ITEM 6. DEVELOPMENT APPLICATION: 5 LINK ROAD - 947 SOUTH DOWLING STREET AND 132-142 EPSOM ROAD ZETLAND**FILE NO:** D/2012/1955**DEVELOPMENT APPLICATION NO:** D/2012/1955**SUMMARY**

Proposal Summary: The subject application seeks consent for a Stage 2 development application for the detailed design of a mixed use development ranging in height from 2 to 14 storeys, and encompasses the following:

Summary Recommendation:

Figure 20: Overlay of approved Stage 1 building envelope on Building A

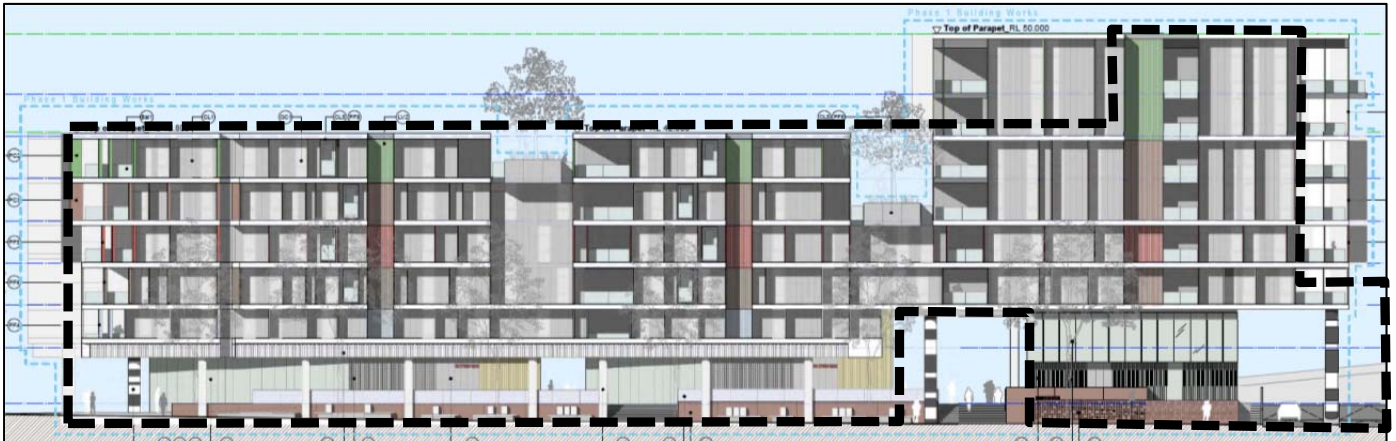
Stage 1 consent requirement	Comment
Building Setouts (Condition 51) Building Envelopes (Condition 52)	<p>The proposal seeks minor variations to the building envelopes from those approved in the Stage 1 consent. The location and extent of these variations in the Stage 1 envelopes are detailed in Figures 20 to 22, below.</p> <p>As detailed in Figure 20, the proposal has transferred floor space from the lower southeastern corner of Building A and instead has relocated this floor space to the upper floors. No objection is raised to this variation as:</p> <ul style="list-style-type: none"> • the overall maximum height and width of the building is retained; • the varied envelope does not result in any greater amenity or environmental impact to surrounding sites; and • the relocated floor space would receive better amenity than if delivered at these lower levels, adjacent to the freeway. <p>In addition to the above, there are elements on Buildings B and C where minor variations to the envelopes/footprints are proposed. As the approved Stage 1 envelopes have not been wholly utilised, and the variation is resulting from articulation of balconies and/or architectural features, no objection is raised to these minor elements of variation.</p>

Figure 23: The proposed location of the 13 at-grade visitor car parking spaces

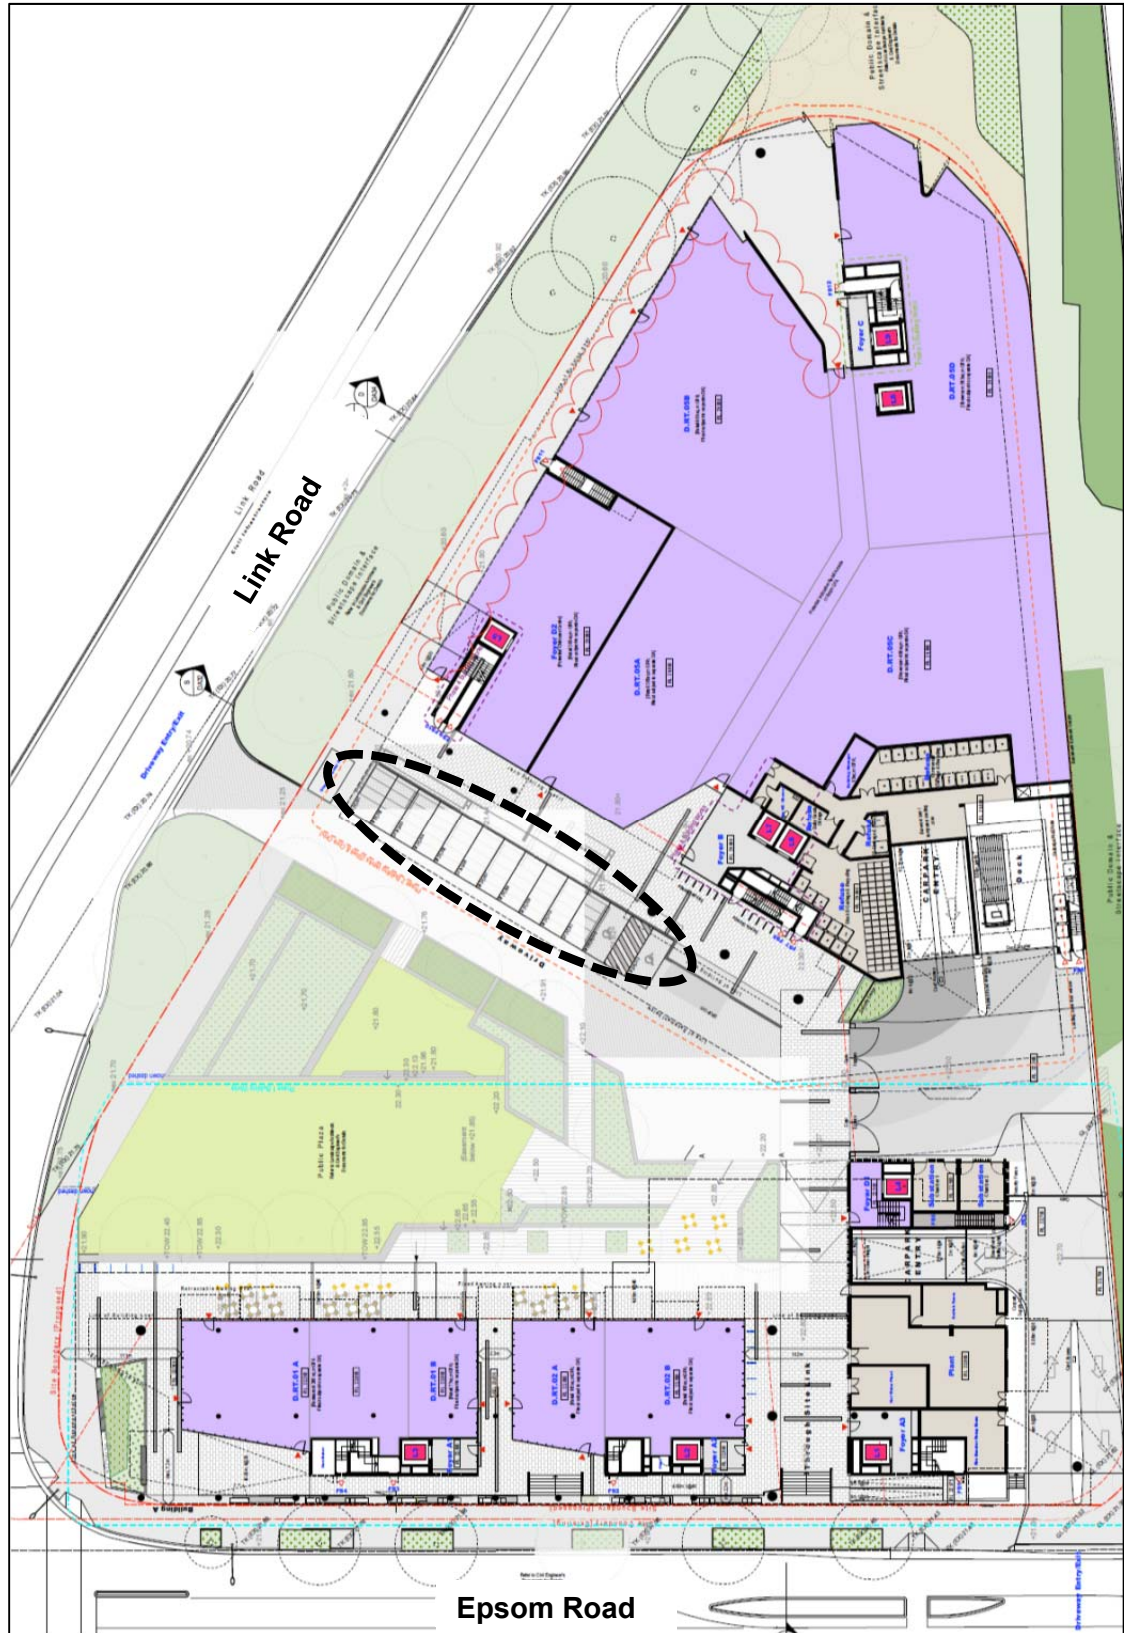
87. The proposal incorporates 13 visitor car parking spaces along the northern side of the internal access driveway adjacent to the retail tenancies of Building D (refer to **Figure 23**, below). These would be private car parking spaces that are not controlled or regulated by Council.

89. The subject application is approving generic retail and commercial floor plates only, with the future uses of these spaces to be the subject of further development applications. Sufficient car parking has been provided within basement level 1 to cater to the needs of the generic retail and commercial floor space. Should any future use have more specific car parking requirements, such as child care drop off/collection requirements, then consideration of the appropriateness of the amount and location of car parking, can form part of the assessment of the detailed use development application. Any consideration or approval of these spaces at this time is considered to be premature.

90. It is recommended that a design modification condition be imposed to advise that no consent is granted to these 13 car parking spaces and that an alternate landscaping or paving treatment be provided adjacent to the colonnade entry of Building D.

91. As a result of the deletion of these 13 car parking space, the total number of parking spaces provided on the site reduces to 264. The table, below, provides a breakdown of the proposed and permissible on the site. It is noted that should a future use development application seek to reinstate these at-grade car parking spaces, the non-residential parking provision is beneath the maximum permissible under Sydney LEP 2012.
